Final Environmental Impact Statement for the Mineral Resource Management Plan

Potential Exploration, Development,
and Production of Oil and Gas Resources

Vandenberg Air Force Base

FINAL ENVIRONMENTAL IMPACT STATEMENT

Figure 6.5-10
REGIONAL ONSHORE GEOLOGICAL MAP
Central Santa Maria Basin

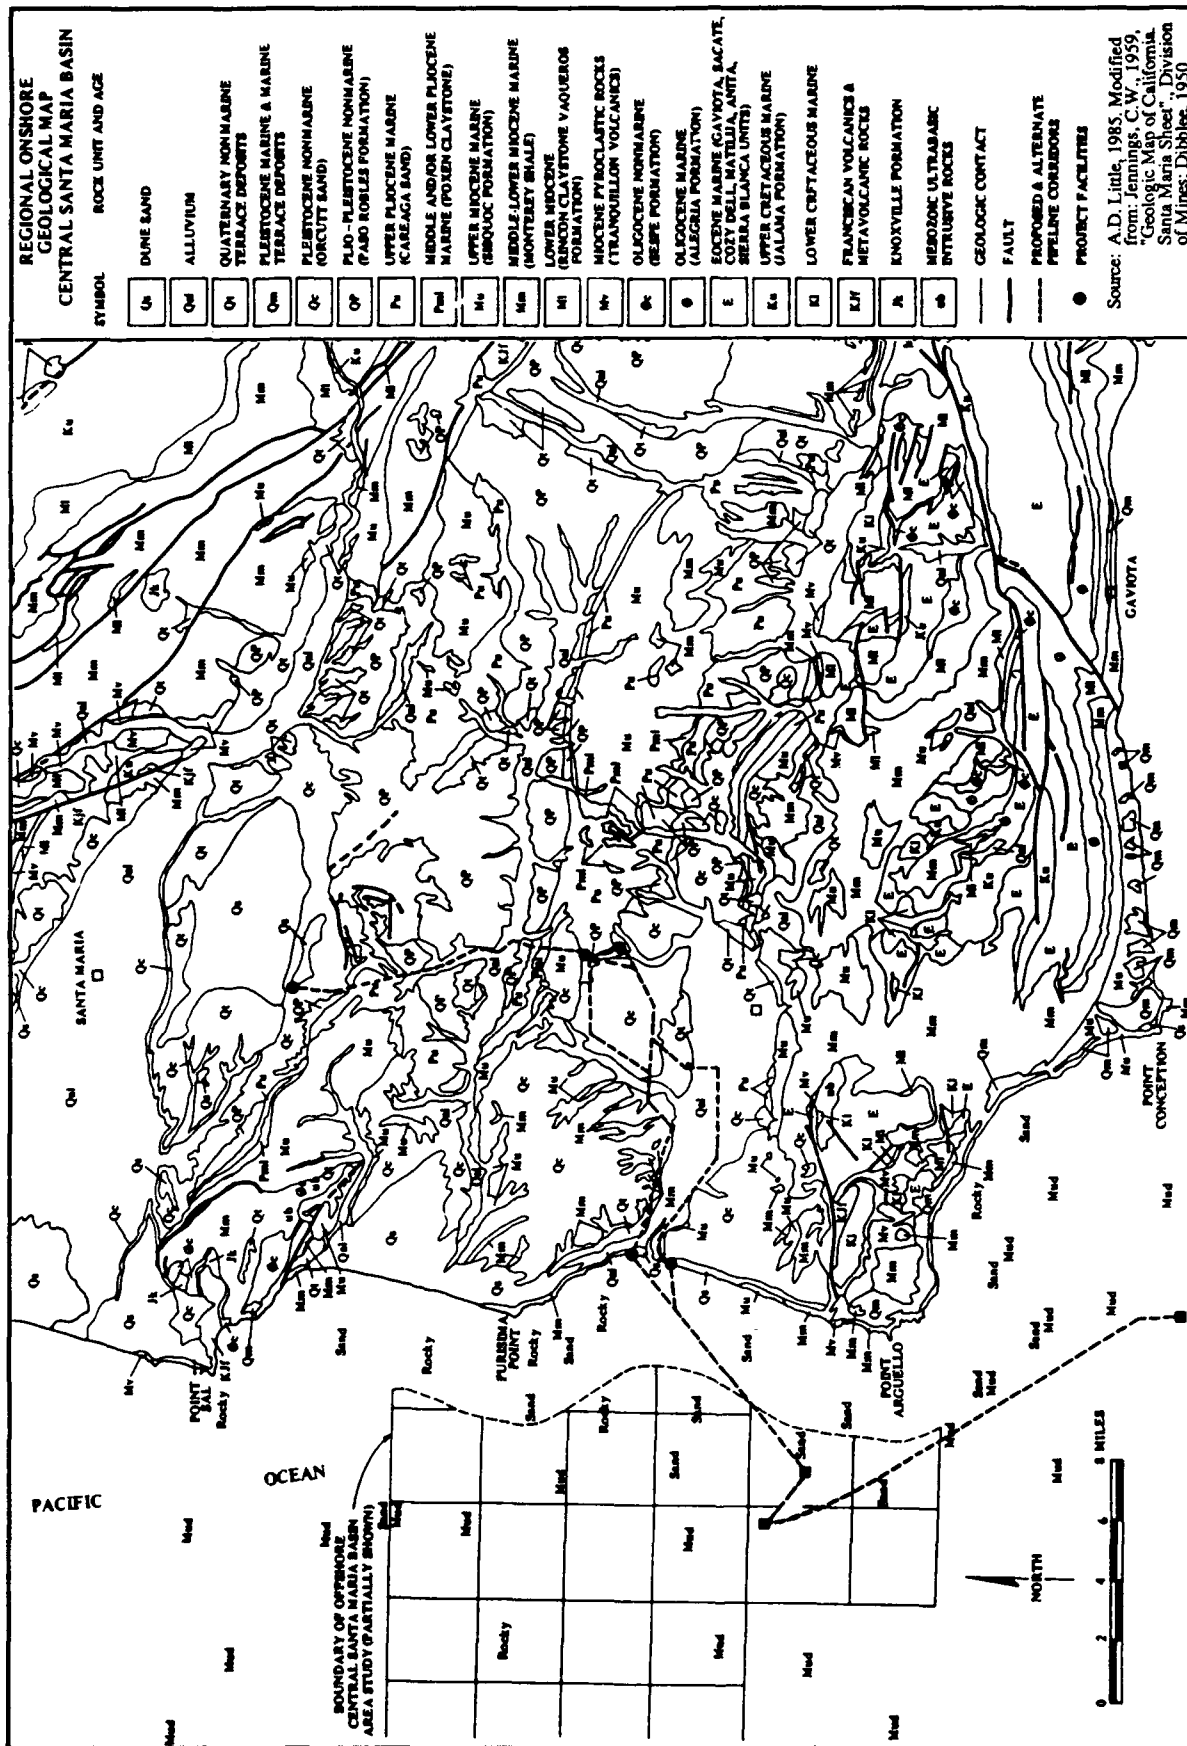
More detailed information about the potential of various formations for containing vertebrate fossils and the distribution of the formations can be found in Table 6.5-4 and in Figure 6.5-10 (see the attached table and figure). Note that in Figure 6.5-10, the map unit Q_m includes both marine and continental terrace deposits that are symbolized by QT_1 , QT_2 , and QT_3 in Table 6.5-4.

Figure 7-2

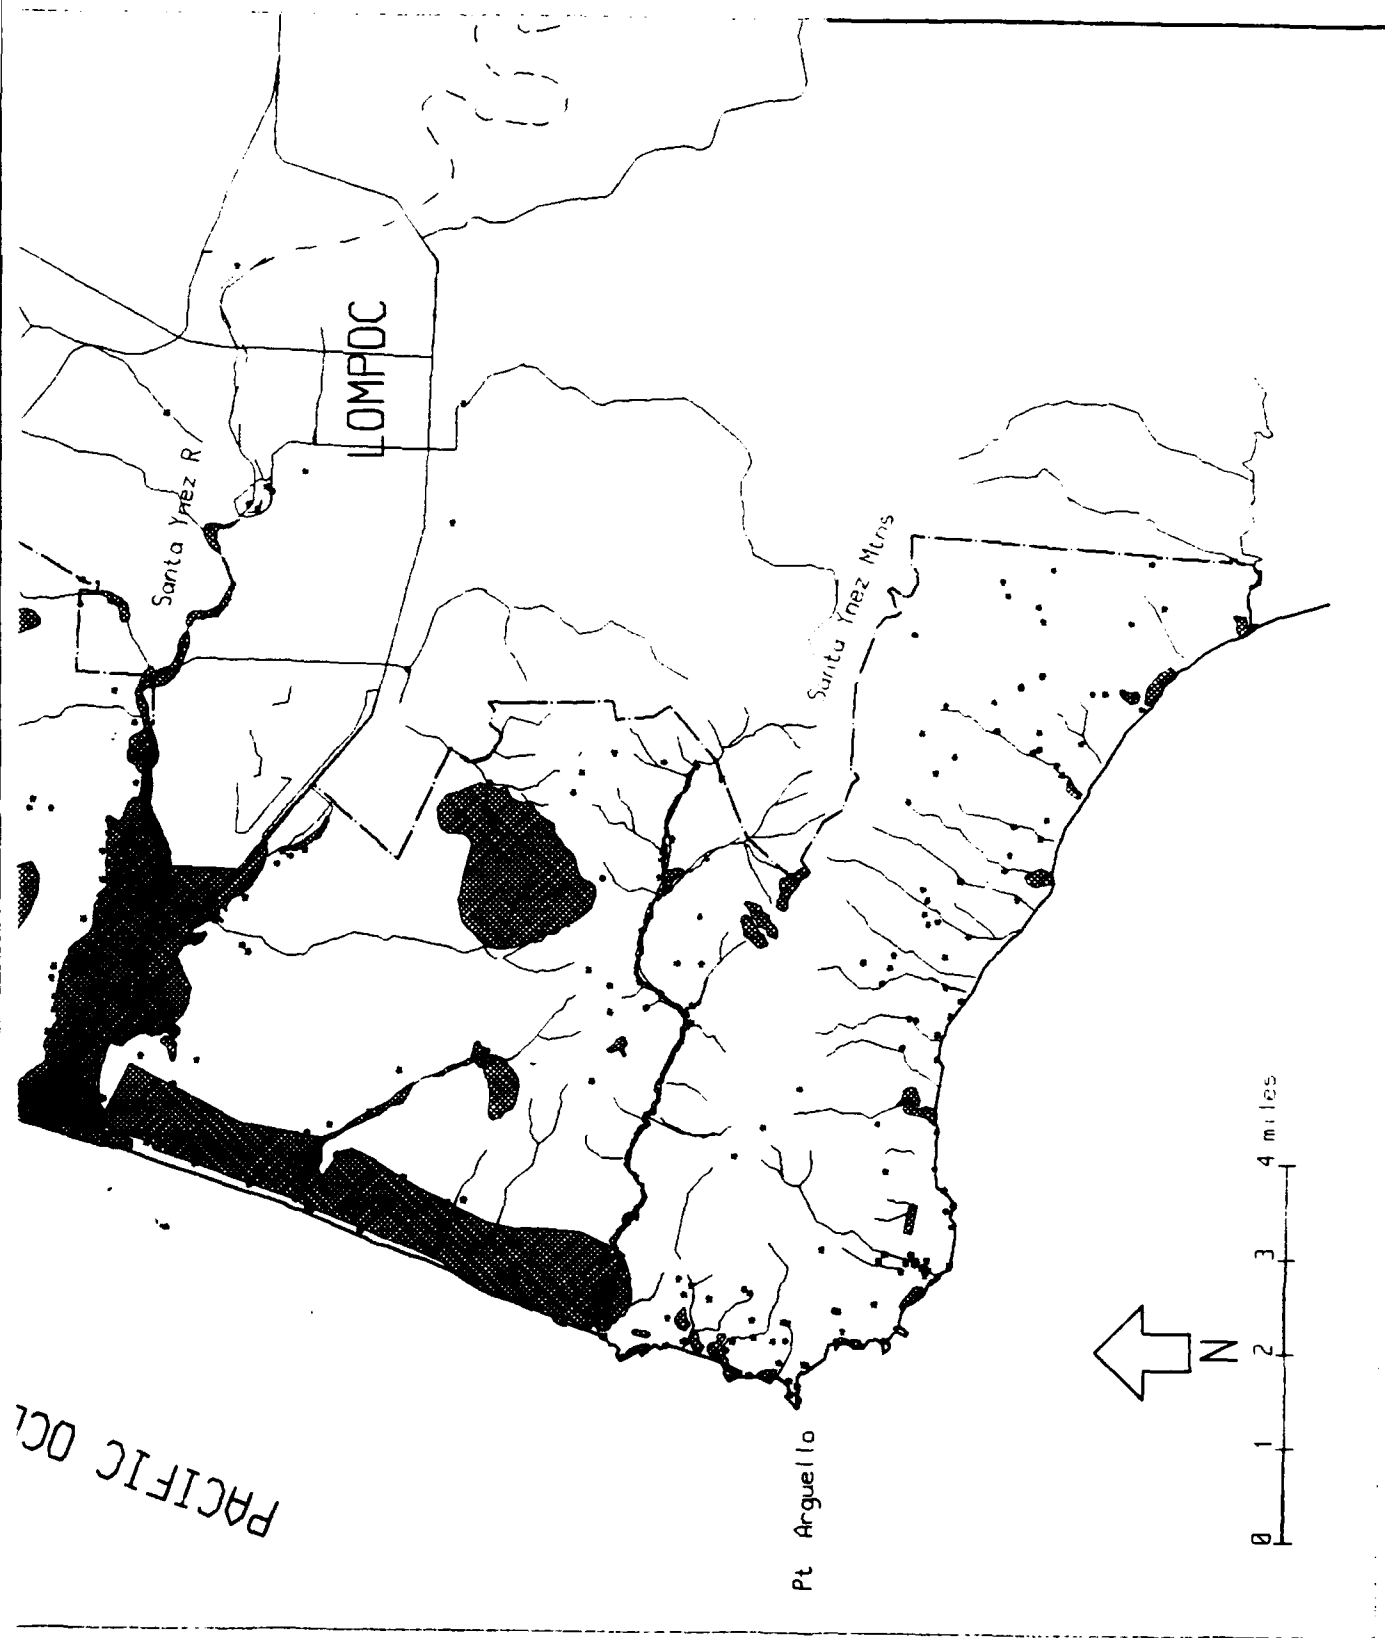
18. Figure 7.2, page 7-7. The LEGEND block is empty; either Legend text must be added, or the block must be removed. Also, this figure should include all lands within the Lompoc and San Antonio Groundwater Basins, since overdrafted groundwater resources are acknowledged in the text as a "high environmental constraint (see e.g. Sec. 6.2.4.1, p. 6.2-21, middle of first full paragraph; Sec. 7.3.3.2, p. 7-6).

- RMD-131 See the response to comment SLC-1.
- RMD-132 The legend is unnecessary and has been deleted from Figure 7-2. Please see the MRMP errata for section 7.0, Plan Criteria and Application. The referenced map gives information on locations of oil and gas facilities which may be constrained by water resource attributes. As noted in the response to comment RMD-83, the location of oil field development is not geographically tied to the location of the water source which would supply the facility. The purpose of this figure is to provide geographic information on constraints of oil and gas development on base.

A legend is unnecessary for Figure 7-2, Composite Environmental High-Constraint Areas, on page 7-7; therefore, the legend inset has been removed. See attached figure.
